Re: **The Parklands Village V2F1 – Site Plan and Plat - Response to Comments (2022-4054-00; 2022-3092-00)**

## SECOND TECHNICAL REVIEW

**SHEET TITLE:**  
 SITE PLAN  
 DETAILS

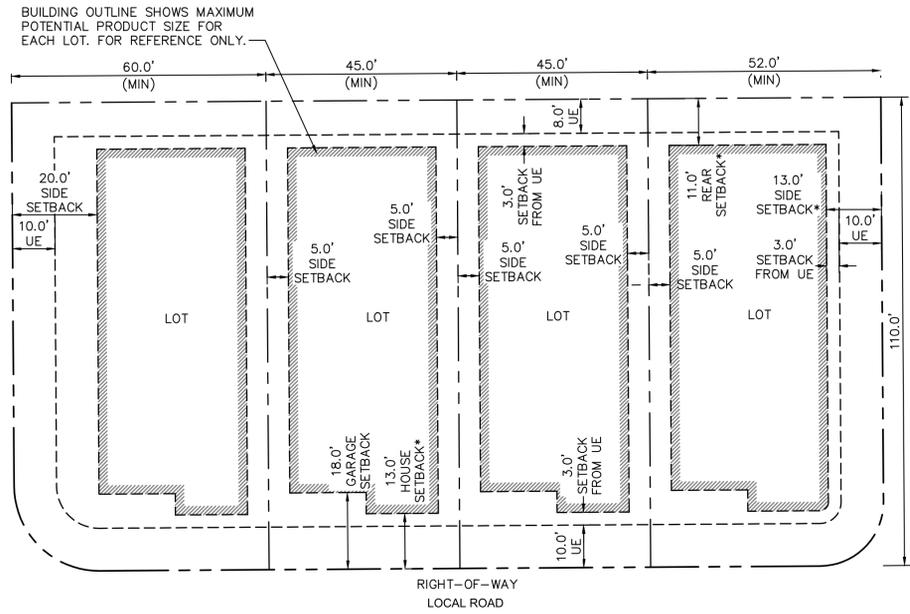
Provide correspondence from Waterstone identifying their acceptance of this responsibility in the next submittal.

Parklands Waterstone agreement provided as separate PDF with resubmittal

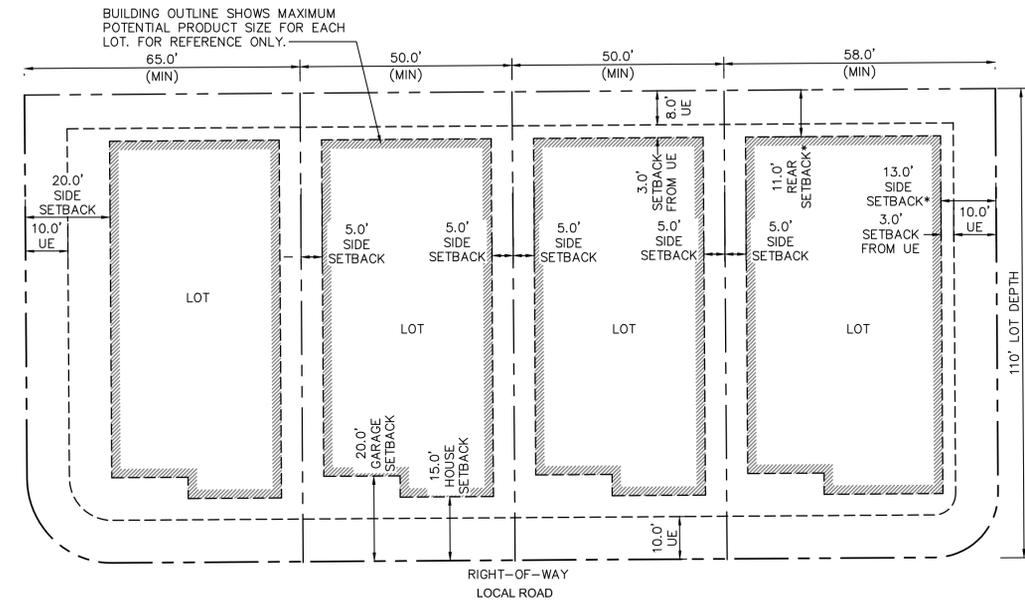
change to: Fire Lane, Sanitary Sewer, Water & Access easement (see sheet 7) (match the plat)

Call out has been updated to "Fire Lane, Sanitary Sewer, Water & Access easement" to match the plat

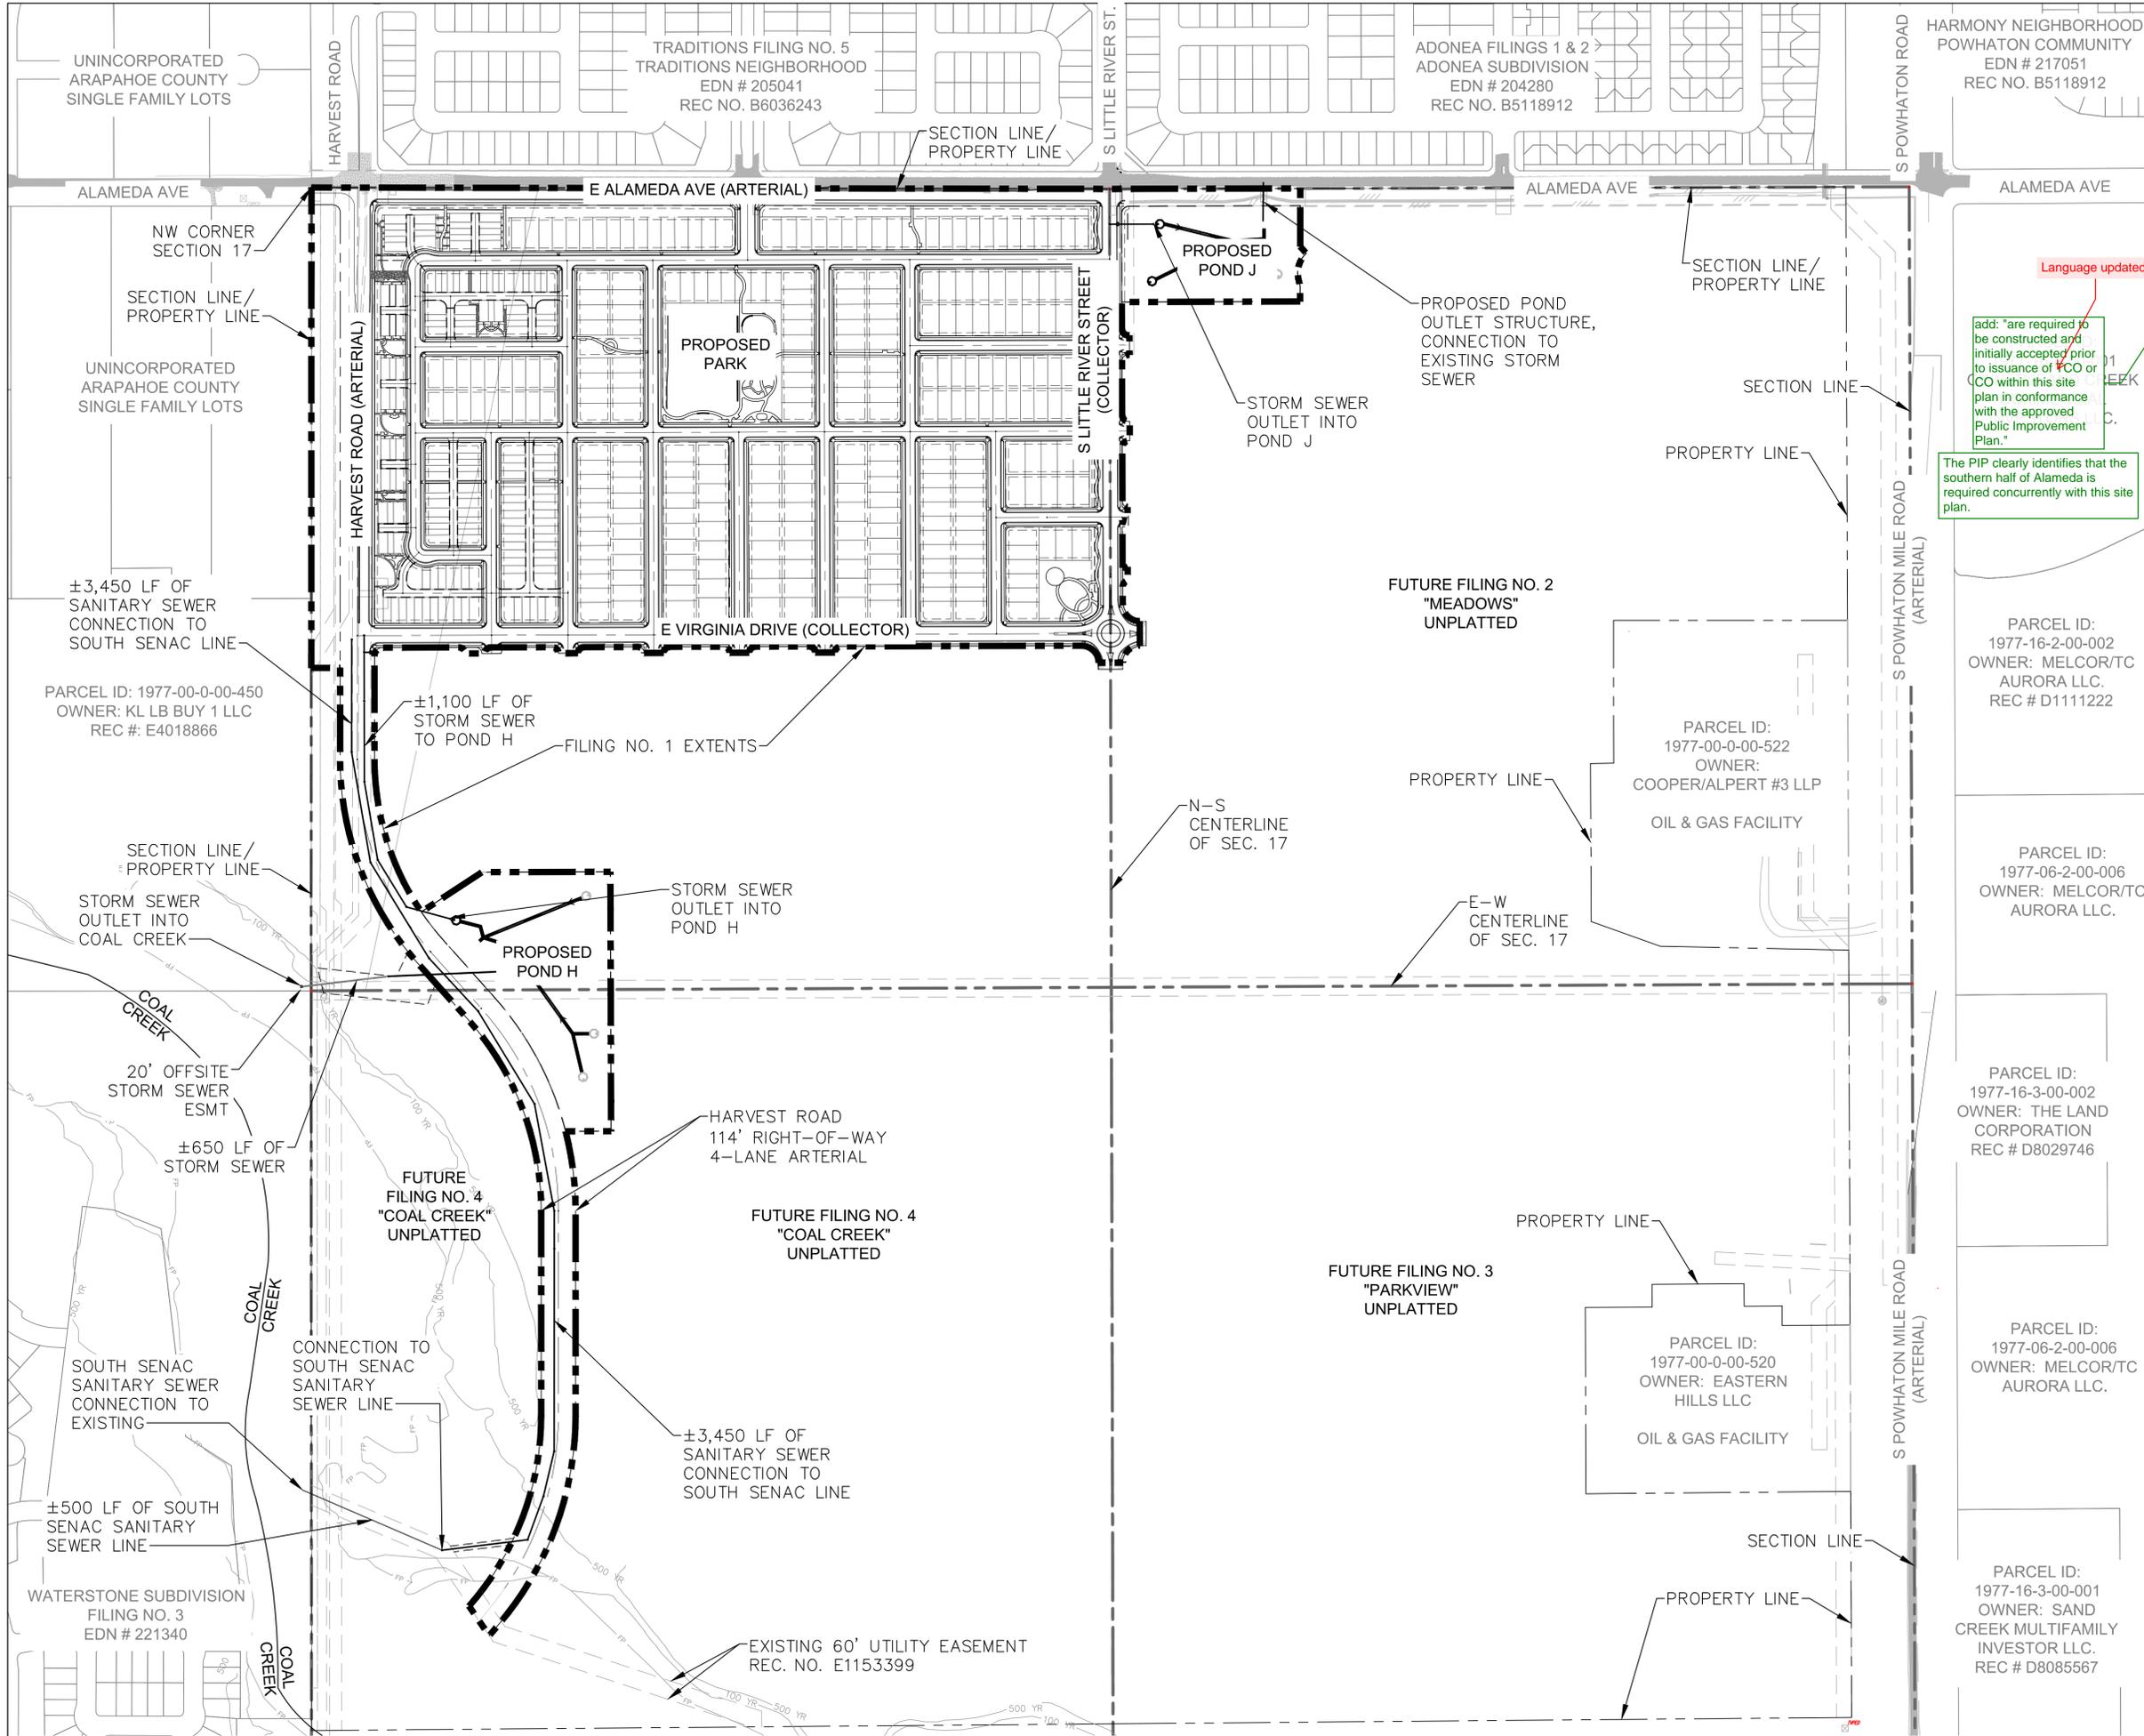
add: "are required to be constructed and initially accepted prior to issuance of FCO or CO within this site plan in conformance with the approved Public Improvement Plan."

The PIP clearly identifies that the southern half of Alameda is required concurrently with this site plan.

Language updated.

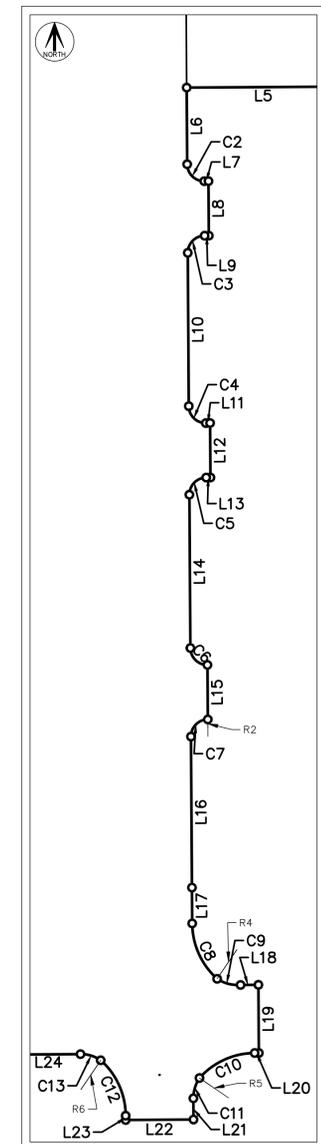
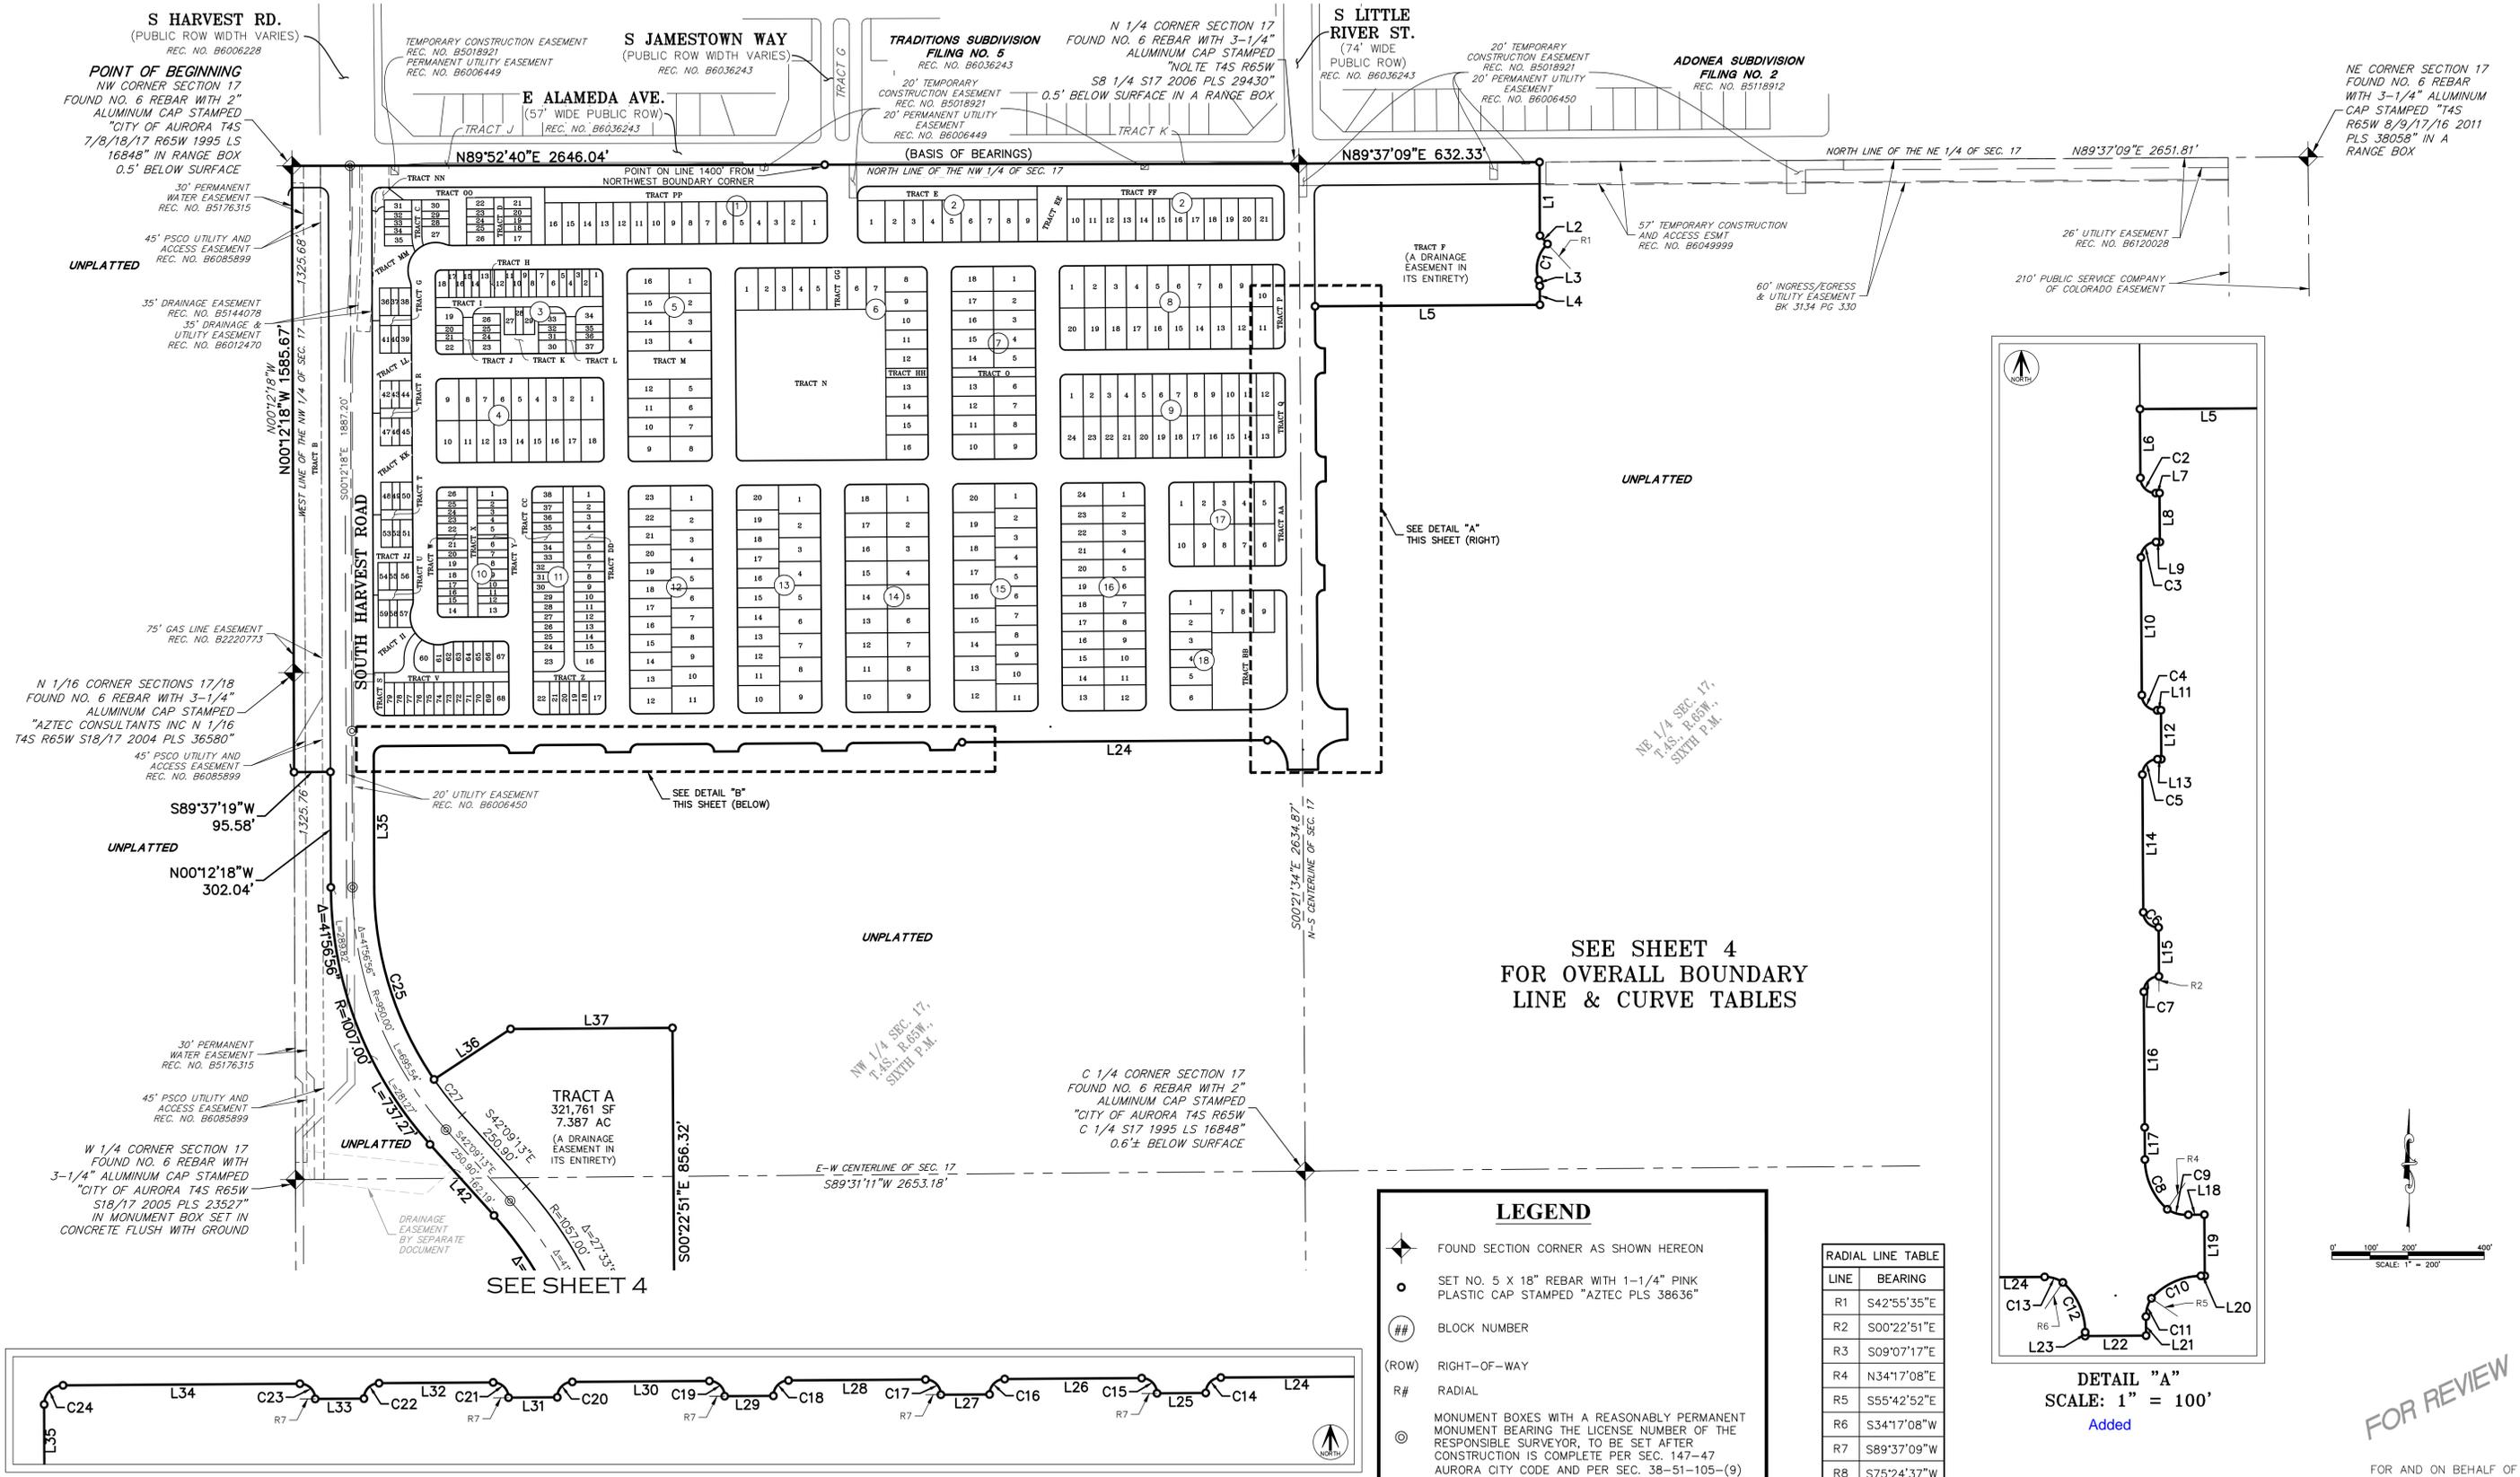
delete these from the Plat Notes - move them to the Legends

Removed, legend contains this info already
